13 November 2021

Verification of the authorised Brandvalley wind energy facility (WEF) turbine layout, in relation to the bat sensitivity map and impacts on bats.

Figure 1: Bat sensitivity map of the Rietkloof site with proposed turbine layout.

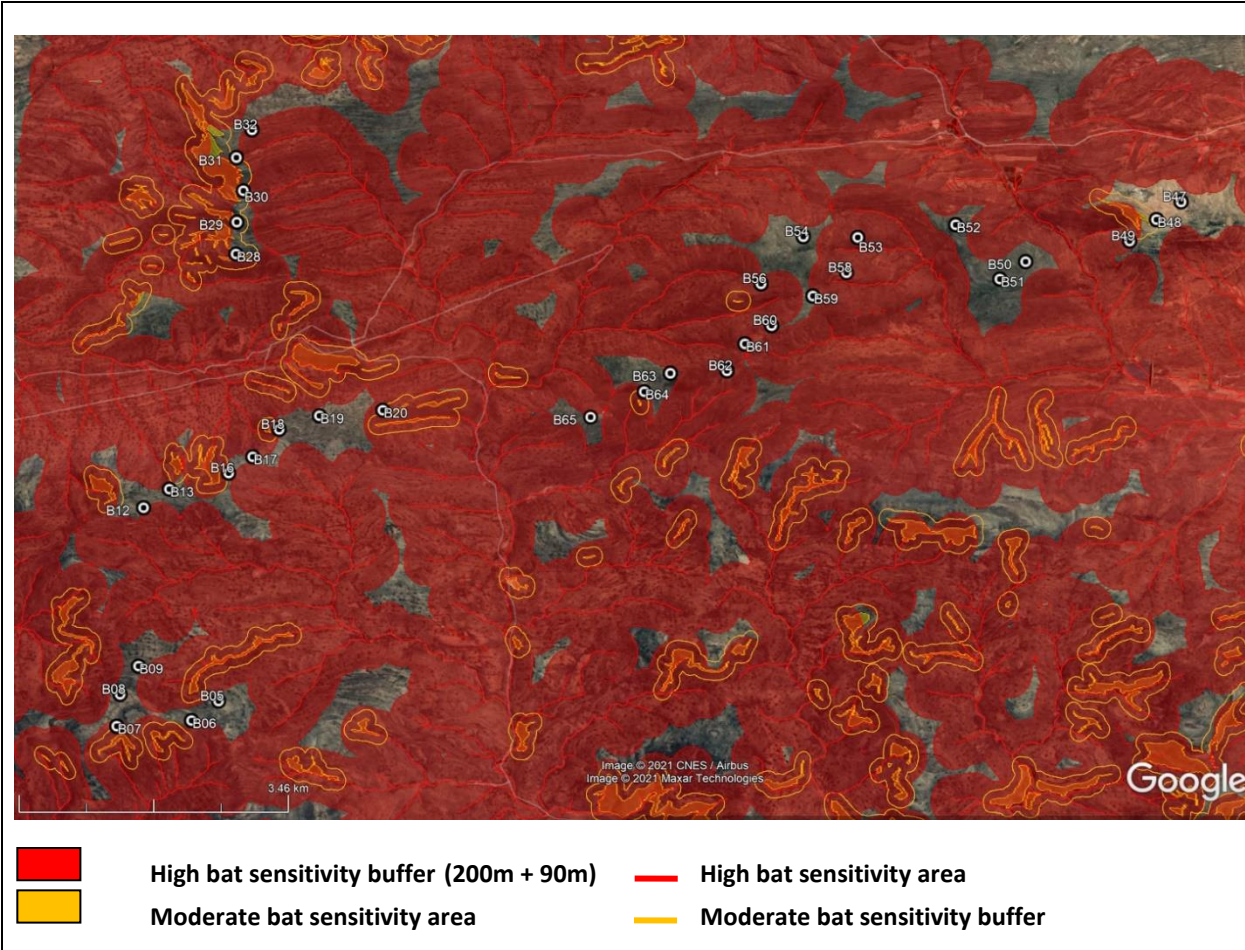
A site visit was conducted on 13 September 2021 by Animalia Consultants (Pty) Ltd to verify the turbine layout in relation to the approved bat sensitivity map. The proposed turbine layout respects the bat sensitivity map as was applicable during the preconstruction guidelines that was in use during the EIA assessment and subsequent amendments (**Figure 1**). It also respects the current guideline criteria which requires turbine blade length to be outside the high sensitivity buffers, except for Turbines B20, B32, B49, B53, B58.

On a flat surface the distance from a high sensitivity must be 200m, which constitutes the high sensitivity buffer. This includes all parts of a turbine such as the turbine blades, and is in line with the MacEwan, et al. (2020) Preconstruction Guidelines. Therefore, based on a rotor diameter of 180m (blade length of 90m), the turbine base position must be 290m or more from any high bat sensitivities and 90m from high sensitivity buffers. However, in this case the actual bat sensitivities are at a lower elevation in valleys and the turbines are proposed on the ridges. In cases where the turbine base was closer than 90m to the high sensitivity buffer, a formula was applied to consider the hub height of 125m, 90m blade length and difference in elevation of turbine base and sensitivity. In order to calculate the distance of the base to the buffer required for maintaining a minimum of 200m from a blade tip to an actual sensitivity. This formula was only required for Turbines B20, B32, B49, B53 and B58 since their blades are intruding into the high bat sensitivity buffers.

When considering a 90m blade length, based on above calculation considering the difference in elevation between the bat sensitivity and the turbine base position, Turbines B20, B32, B49, B53 and B58 base centre points should be moved to be outside of the high bat sensitivity buffer. All other turbines proposed can remain in the currently authorised positions. The significance ratings of the original impacts identified will not change as a result of the amendments.

In summary, the proposed layout is acceptable from a bat sensitivity perspective if all conditions of the EA are adhered to, an operational bat impact monitoring study is conducted for a minimum of 2 years, and Turbines B20, B32, B49, B53 and B58 are moved outside of the high bat sensitivity buffer.
